# 2018 Site Management Plan

Defense Depot Memphis, Tennessee U.S. EPA I.D. Number TN4210020570

Revision 1 June 2018

# Responses to Comments from U.S. Environmental Protection Agency (EPA) Region 4 on: 2018 Site Management Plan, Revision 0, January, 2018 Defense Depot Memphis, Tennessee Comments Received: 11 April 2018

#### Figure 25 Master Schedule

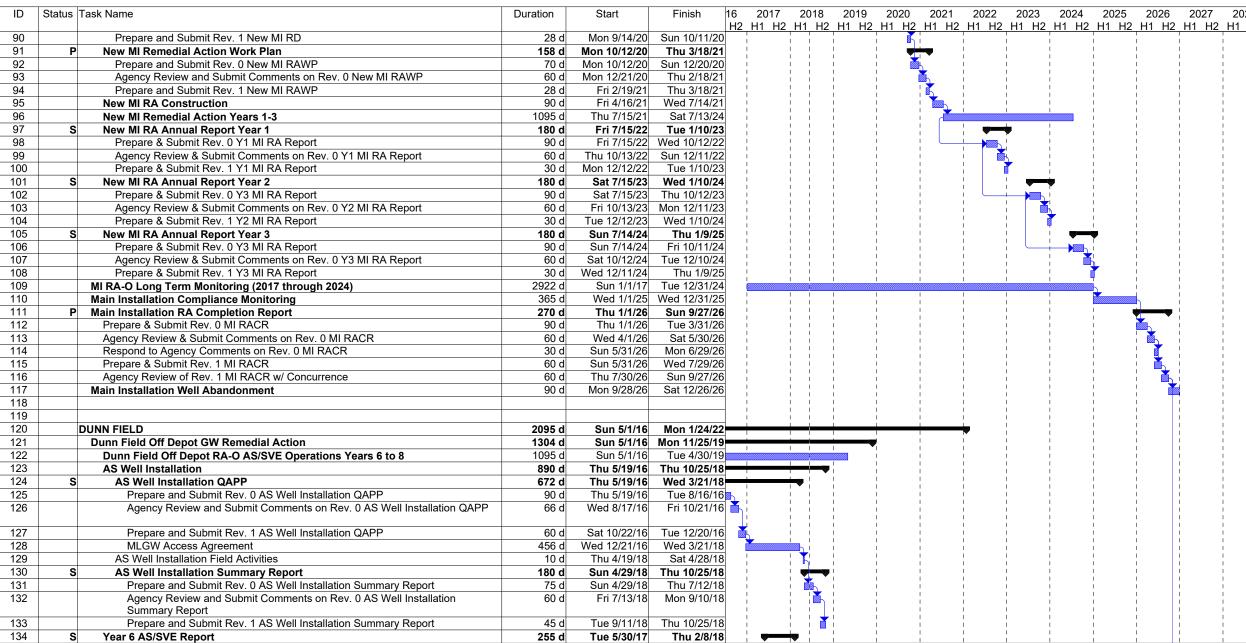
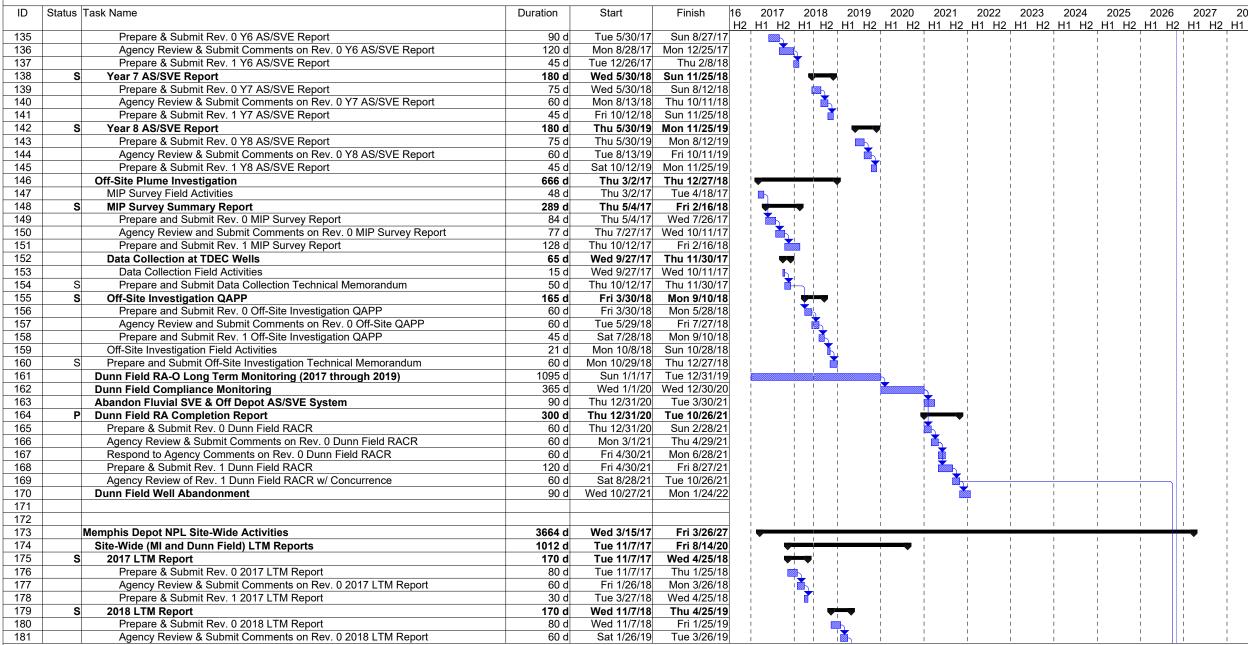
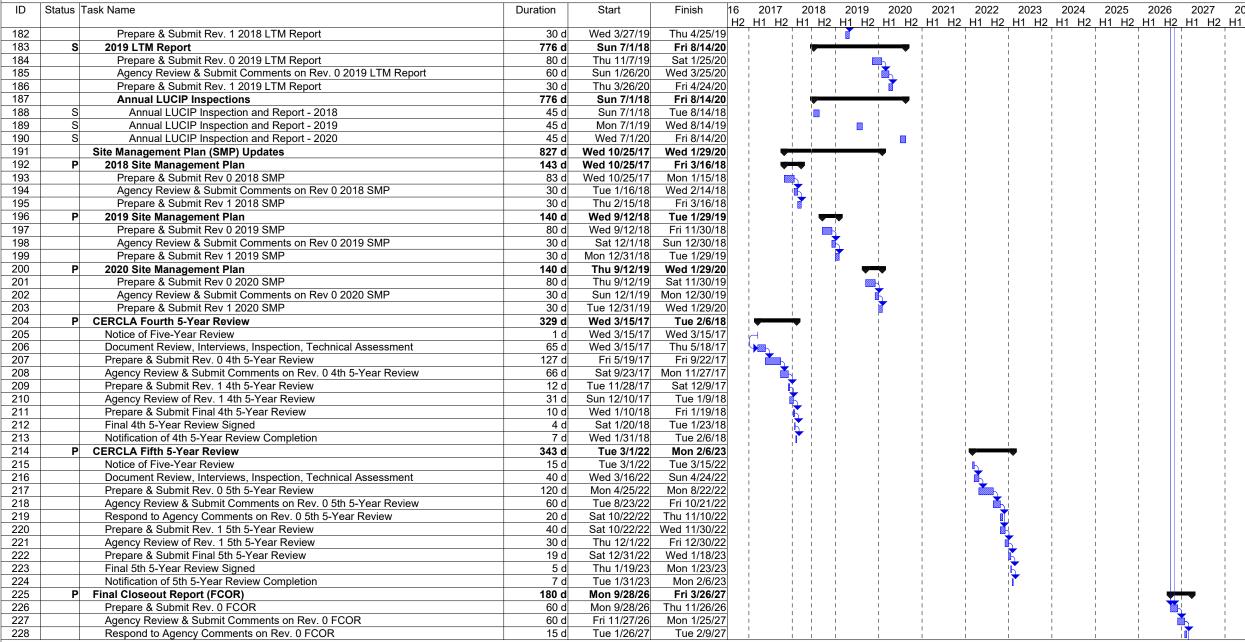
- 3. The data in the Figure 25 for the completion date of the FFS is 1/9/25 however, in Section 4.5 Timeline for Site Completion of the FFS is listed as December 2020.
  - a. Please provide clarification with respect to the anticipated time frame/completion date for the FFS.

#### 7. Figure 25

a. Please provide a definition (key) for the S and P notated in the Status column

- P: Primary Document
- S: Secondary Document
- b. If possible, could a column be added to <u>future</u> SMPs that includes what type of document (target/deadline), when appropriate? (ie: this won't apply to all rows).

**Response**: The currently scheduled completion date for the FFS is 1/17/20. The setting of tasks and sub-tasks on Figure 25 is incorrect, which resulted in an incorrect date for the FFS being shown; the schedule will be corrected.

**Response**: The following notes will be added:

**Response**: The existing Status column provides that information: **P** designates a Primary Document with a scheduled Deadline date for submittal; and **S** designates a Secondary Document with a scheduled Target date for submittal.
